# Dragon Glass Bottle Manufacturing Facility

Environment Statement Addendum

Reference: DRAGON-ARUP-ENVZ-XX-RP-T-000009

Final | 27 September 2023

Figure 2 Furnace and generator locations for the consented and 2023 revised schemes

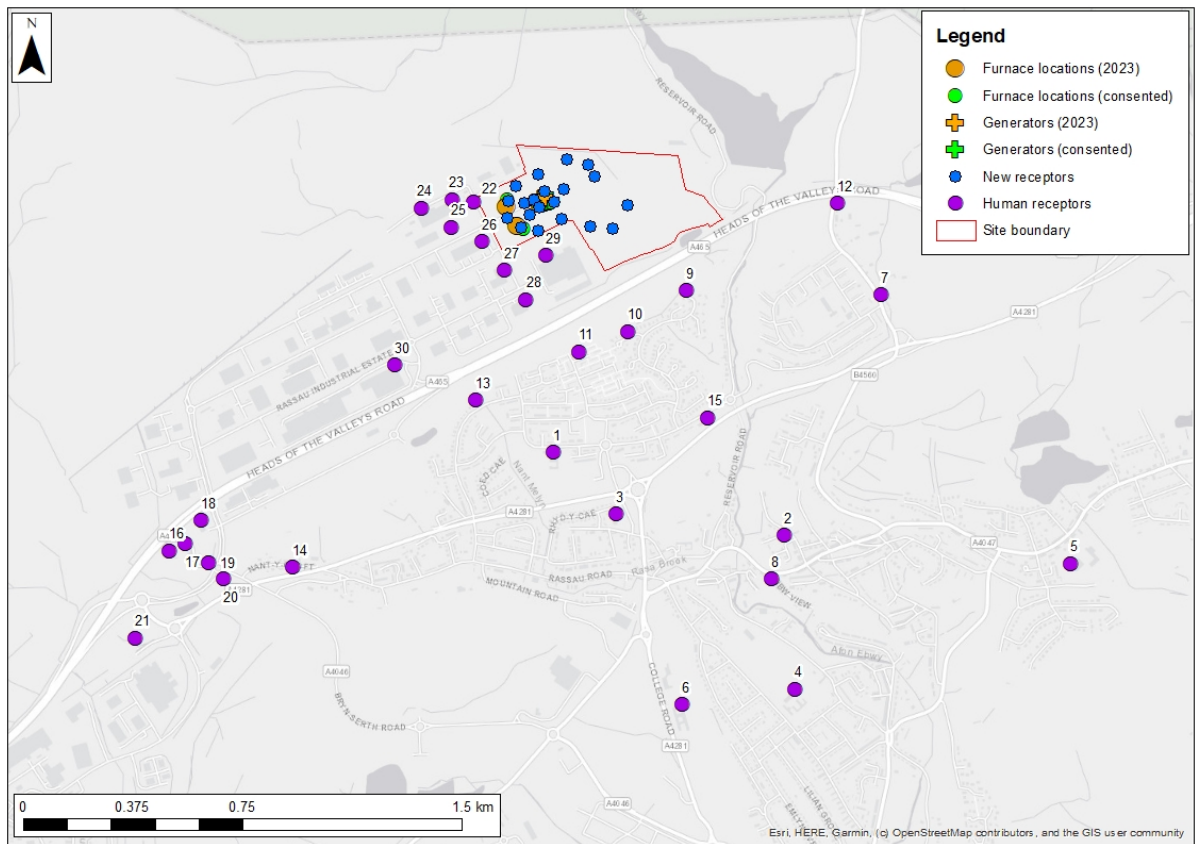
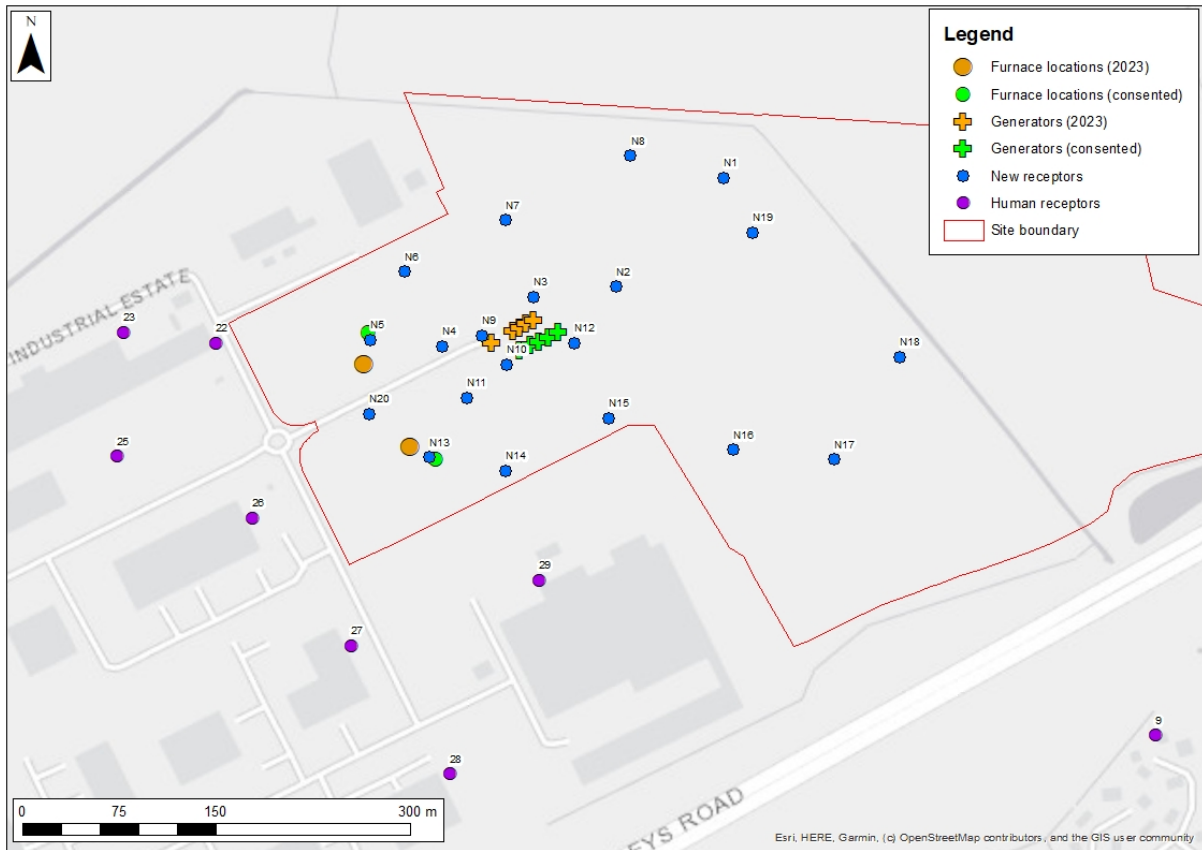
In the revised scheme, the stack heights for the two furnaces remain the same as the submitted ES, and the revised stack locations will be relocated to approximately 20m southwest/ northwest of the original locations due to the redesign of the onsite buildings.

The heights of the onsite buildings have been revised (the main roofs have been reduced by approximately 7m and 14m), though the building orientations are largely similar to the original scheme.

The main source of air emissions from the proposed development is the furnaces. The stack heights are unchanged and distances to relevant receptors will only vary by a very small amount of the original distance assessed (up to 20m). Further, the worst case receptors had already been assessed in the consented scheme, notably to be two existing receptors (IDs 11 and 27) and a new receptor assessed in the original ES (ID N20) are all closer to the consented stack locations, in comparison to the revised locations. Therefore, the updated design is unlikely to cause any material difference to the air quality results in the consented scheme, and therefore no further assessment is required.

In support of the above description, Figure 2 shows the furnace and generator locations for the consented and 2023 revised scheme below.

**Figure 4: On-Site Stacking Spaces**

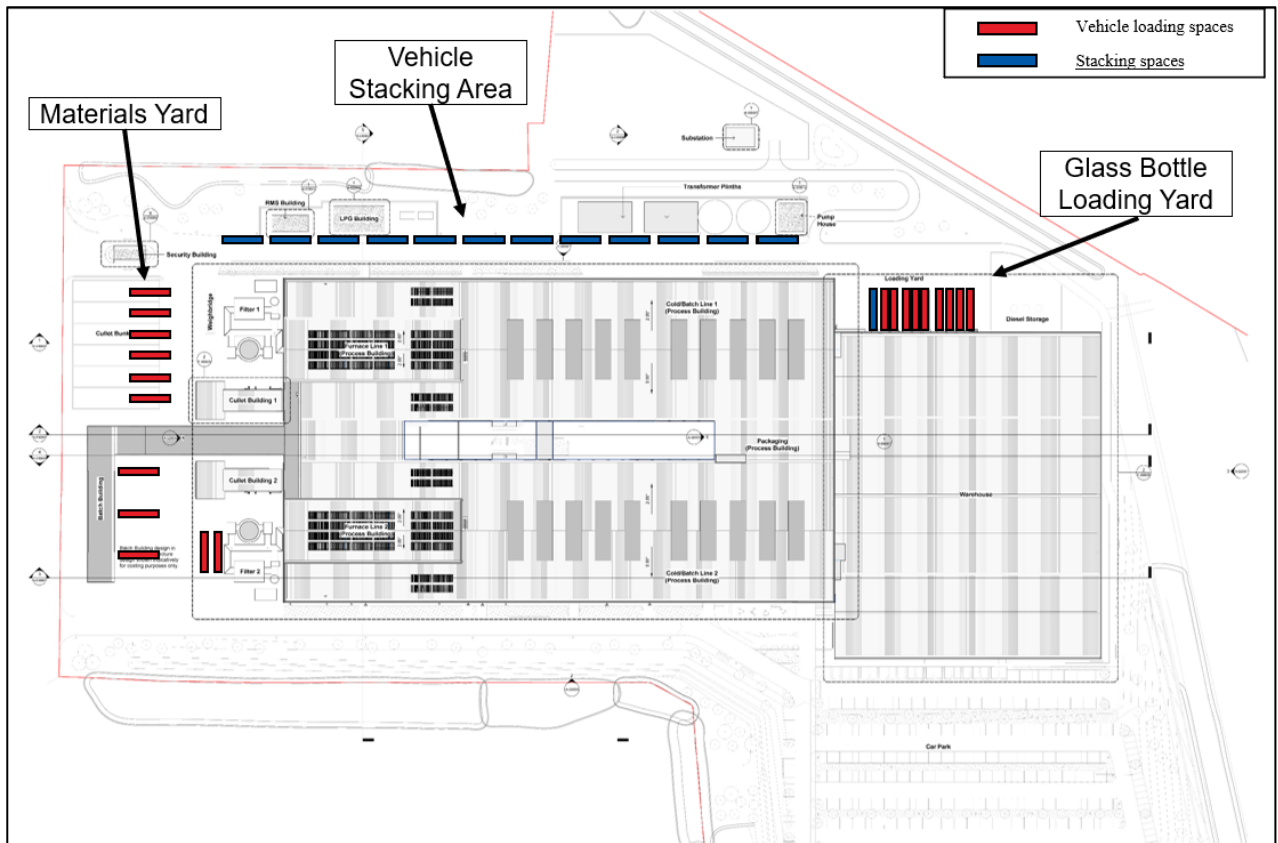
The previous assessment showed the materials yard could accommodate up to eight vehicle loading bays, with sufficient capacity to park five additional vehicles if necessary, while the glass transportation area had the capacity for nine loading bays and a further six waiting spaces.

The assessment has been replicated through use of the revised design for the site, as shown in Figure 4 below. This shows there is sufficient space within the materials yard for 11 vehicles. Meanwhile, the glass bottle yard comprises nine loading bays and an additional vehicle space for stacking, if required. Additionally, a new designated area to the north of the site is proposed with available space for up to 12 vehicles to be parked at this location and would be called when appropriate to unload/load, hence minimising conflict with other vehicles.

Table 6 below provides a summary of the number of spaces available on-site, both for loading and stacking. This shows that the design changes have increased the number of loading spaces from 17 to 20, and number of stacking spaces from 11 to 13.
